Access Compliance Report Public Rights-of-Way (Pedestrian Signals)

Main Street: SIENNA_PKWY Cross Street: CROWN_VALLEY_PKWY Location: E

ADA ID: SGRK211022114631 Signal Type: One Push Button-Non APS Overall Compliance: No Severity Scores: BTN 1: 35 BTN 2: N/A No BTN: N/A

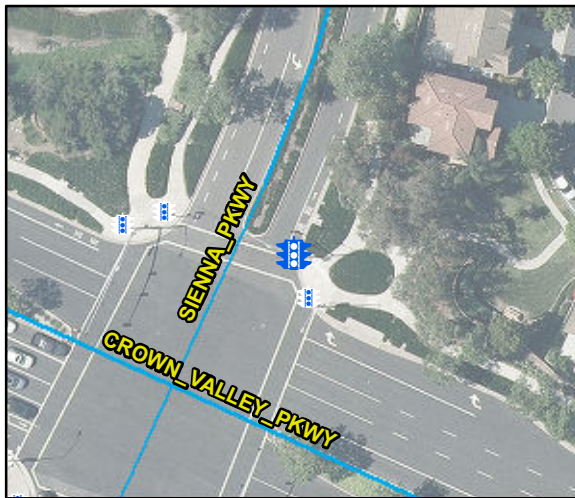
Possible Solutions: Replace Signal Push Button With APS Button. Remove and Replace Clear Space.

OC Std/PROW: R404.2, R404.3, MUTCD 4e.08
